SERVICE TECHNICAL INFORMATION

ONE POINT REPAIR

UTSUNOMIYA, OCTOBER 15, 1996
 REF. NO. : SI-96-033
 CUSTOMER RELATIONS & SERVICE DIV.

MODEL : LCX-700M, XR-M7
 SUBJECT : Does not initialize after power is turned on.
 SYMPTOM : When the set fails to initialize after the power is turned on (Direct Key LED blinks), perform the remedy described below.

Fig.1 Correct Product

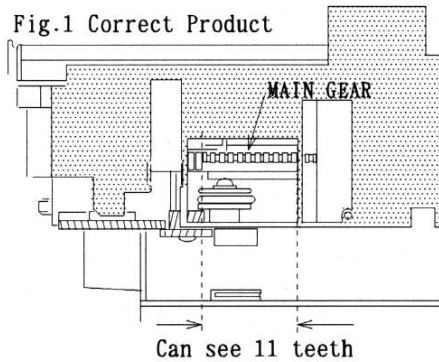
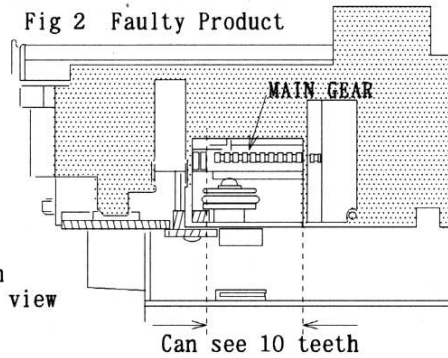
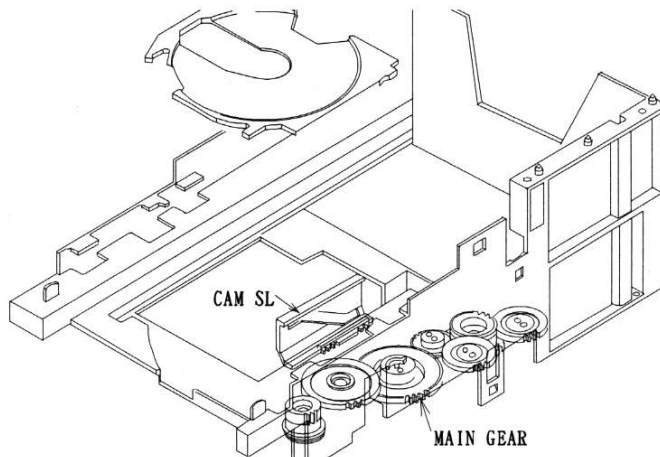
REMEDY : Check the number of main gear teeth while a CD is being chucked (See Fig. 2). If 11 teeth are not seen, replace the CAM SL.

Fig 2 Faulty Product

Replace the CAM SL.

Part No.	Part Name	Ref. No.
84-ZG2-224-110	CAM SL	—
